REPORT AMENDED BY CPC 9-24-87
CITY PLANNING COMMISSION

APPLICATION: Plan Review to allow construction of two warehouse/office buildings totaling 103,680+ square feet on 5.03+ vacant acres in the Light-Industrial-Review (M-1(S)-R)

LOCATION: West side Kelton Way 300+ feet south of Main Avenue

APPLC. NO. P87-292 MEETING DATE: ~~August 13, 1987~~ 9-24-87 ITEM NO. ~~9~~ 5

ELEVATIONS

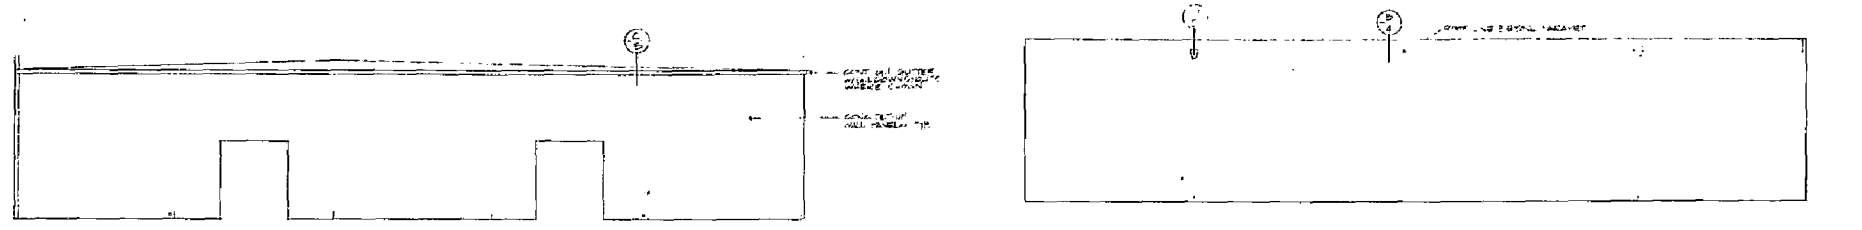
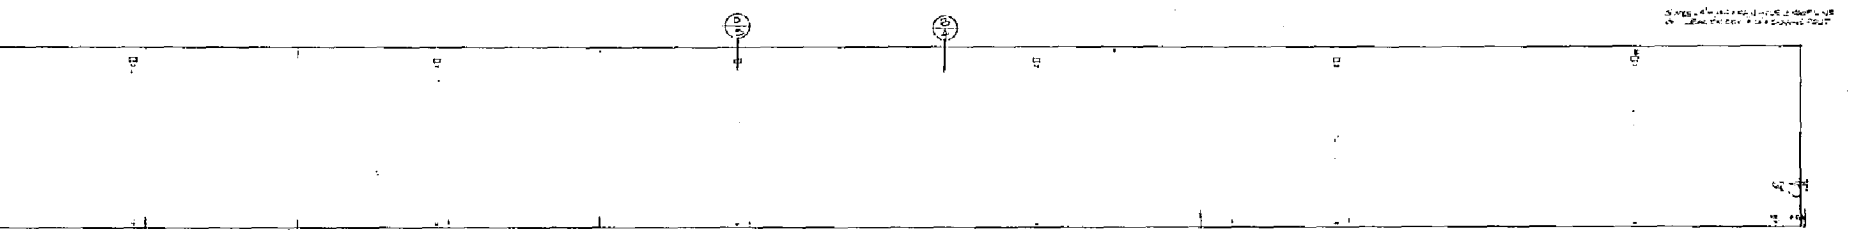
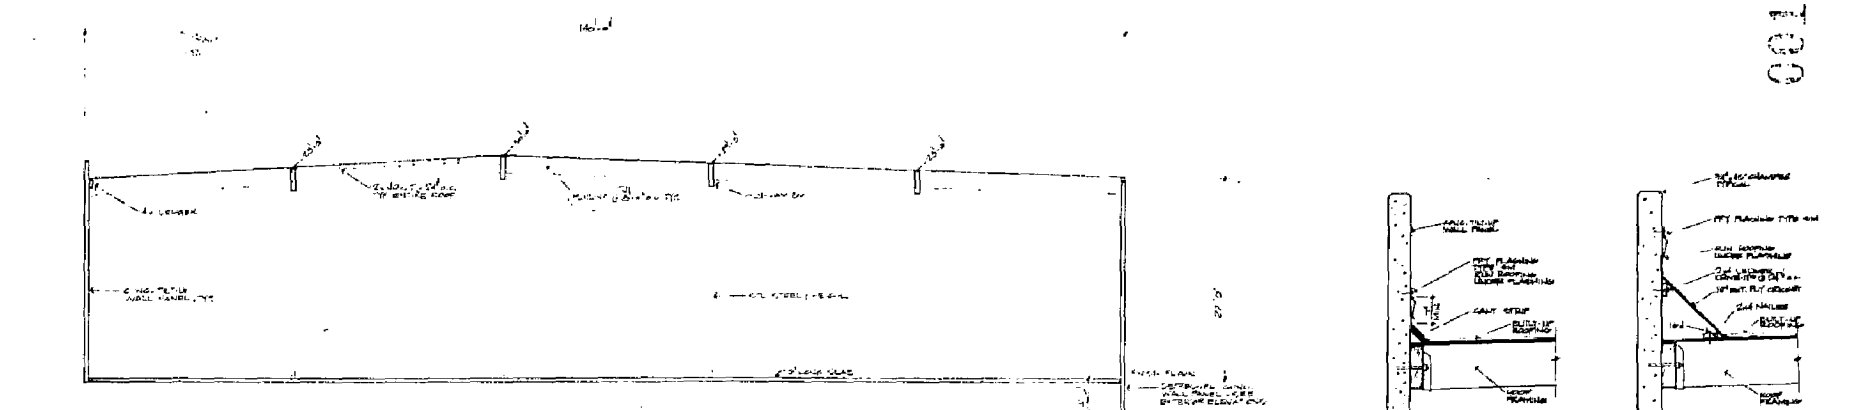
No colors were indicated by the applicant. Staff recommends that elevations visible from Kelton Way be a sandblasted exposed aggregate surface similar to the buildings constructed at 110 and 120 Main Avenue. Paint is allowed on the window trim and accent trim. The roll-up doors and entry doors shall be painted a color to match the building. the color scheme for both buildings shall be reviewed and approved by the Planning Director. Colors shall be earth tone and be compatible with the colors present on the single family dwellings east across Kelton Way and to the south along Bollenbacher. Staff recommends a sandblasted concrete finish on all exterior surfaces rather than painted walls.

2. The applicant shall revise the exterior elevations to the satisfaction of the Planning Director and Design Review Coordinator. All colors and material are to be included in the revised elevations.

35. *The eastern exterior wall that faces Kelton Avenue and the end panels on the north and south side shall be exposed aggregate. (CPC added)*
 36. *The applicant shall eliminate the driveway access onto Kelton Avenue and provide access from Main Avenue if the applicant or the local residences are able to obtain an easement for ingress and egress across the property to the north from Main Avenue. (CPC added)*

EXHIBIT A STAFF MODIFIED SITE PLAN

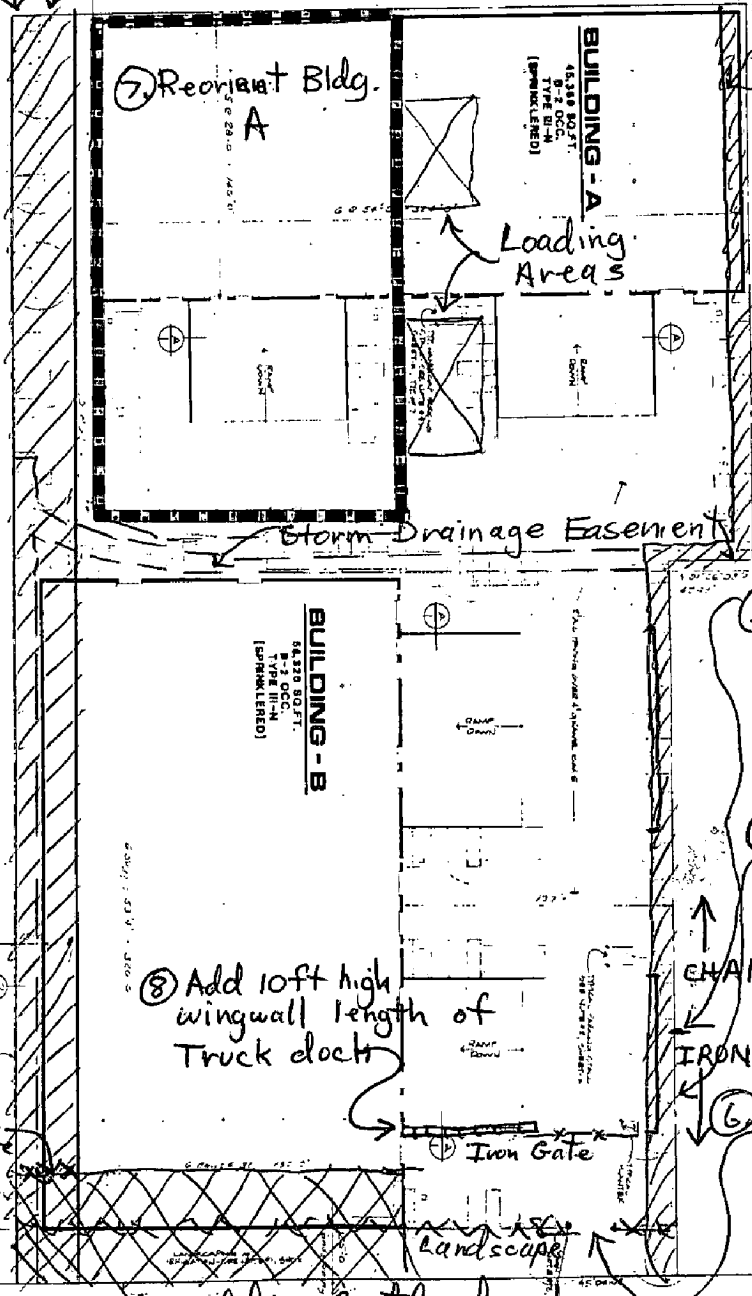
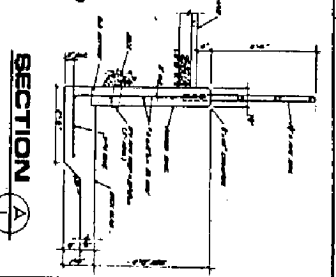
- ① Add 6 ft high solid decorative masonry wall.
- ② Add 25 ft wide landscape strip along South property line.

- ④ Add 10 ft. landscape planter strip along North property line - Reduce planter width to 6 ft. opposite truck loading bay's.

- ⑤ Add 6 ft high decorative wrought iron fence along North property line

- ⑦ Construct 6 ft chainlink fence behind Havlin-Witkin setback

- ⑧ Add 10 ft high wingwall length of Truck dock

- ⑥ Add wrought-iron security gate roll type & Fence along Kelton behind 25 ft Setback on along wingwall

1. The applicant shall prepare a revised site plan, landscaping and irrigation plan for review and approval by the Planning Director prior to issuance of building permits (Refer to Exhibit A).

EXHIBIT A

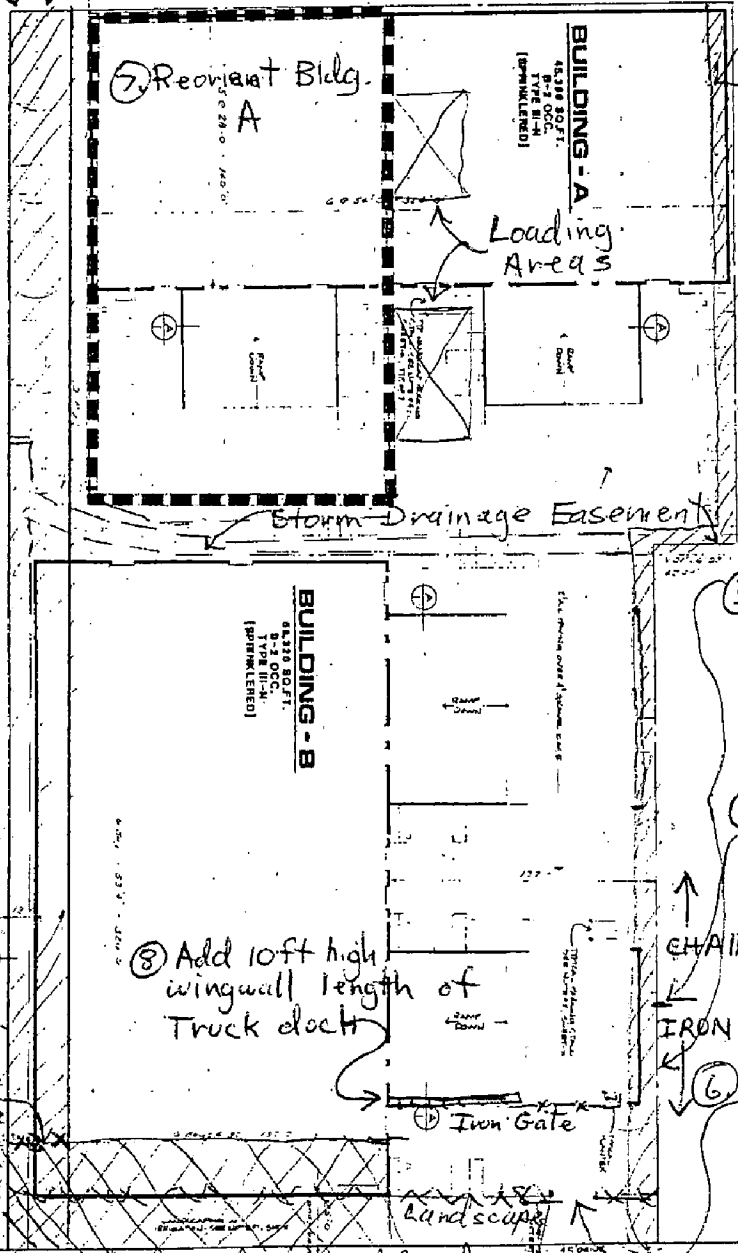
- ① Add 6 ft high solid decorative masonry wall
- ② Add 25 ft wide landscape strip along South property line.

- ④ Add 10 ft. landscape planter strip along North property line. - Reduce planter width to 6 ft. opposite truck loading bay's.

- ⑤ Add 6 ft high decorative wrought iron fence along North property line

- ⑧ Add 10 ft high wingwall length of Truck dock

- ⑥ Add wrought-iron security gate + roll top fence along Kelton behind 25 ft setback or along wingwall

1. The applicant shall prepare a revised site plan, landscaping and irrigation plan for review and approval by the Planning Director prior to issuance of building permits (Refer to Exhibit A).

STAFF MODIFIED SITE PLAN

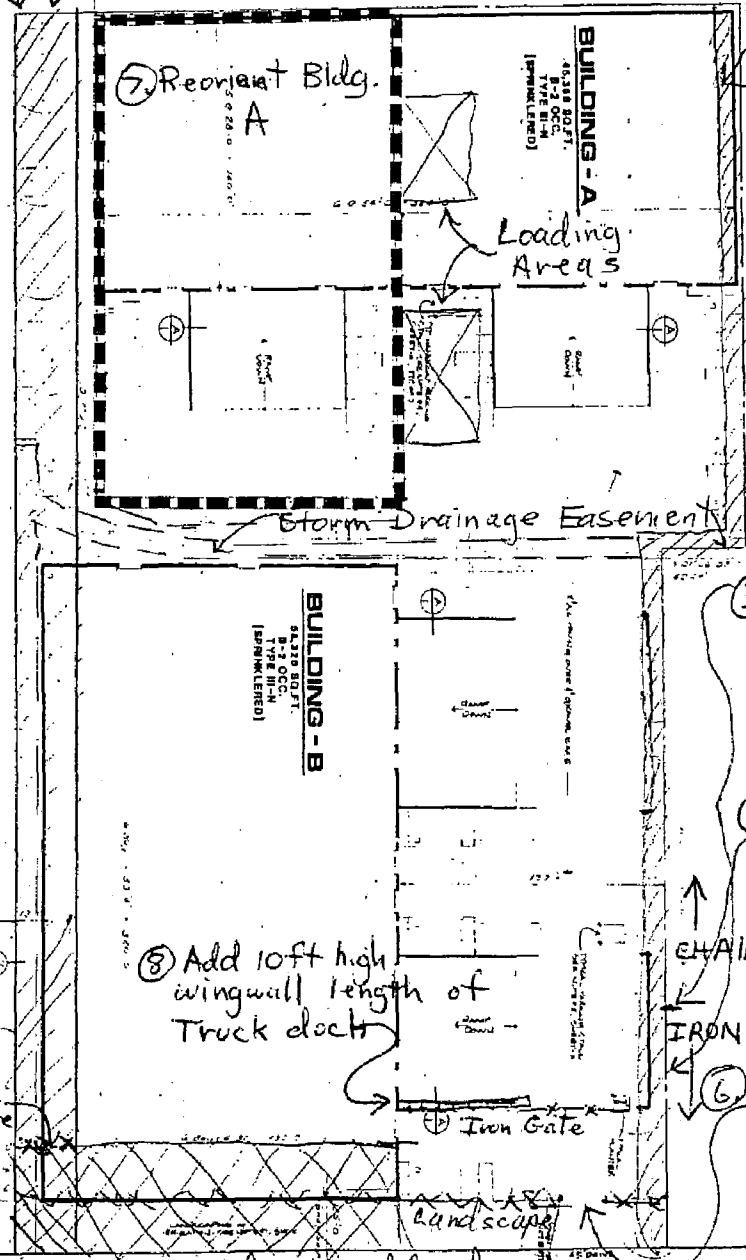
- ① Add 6 ft high solid decorative masonry wall
- ② Add 25 ft wide landscape strip along South property line.

- ④ Add 10 ft. landscape planter strip along North property line - Reduce planter width to 6 ft. opposite truck loading bay's.

- ⑤ Add 6 ft high decorative wrought iron fence along North property line.

- ⑧ Add 10 ft high wingwall length of Truck dock

- ⑥ Add wrought-iron security gate - roll type & Fence along Kelton behind 25 ft setback or along wingwall
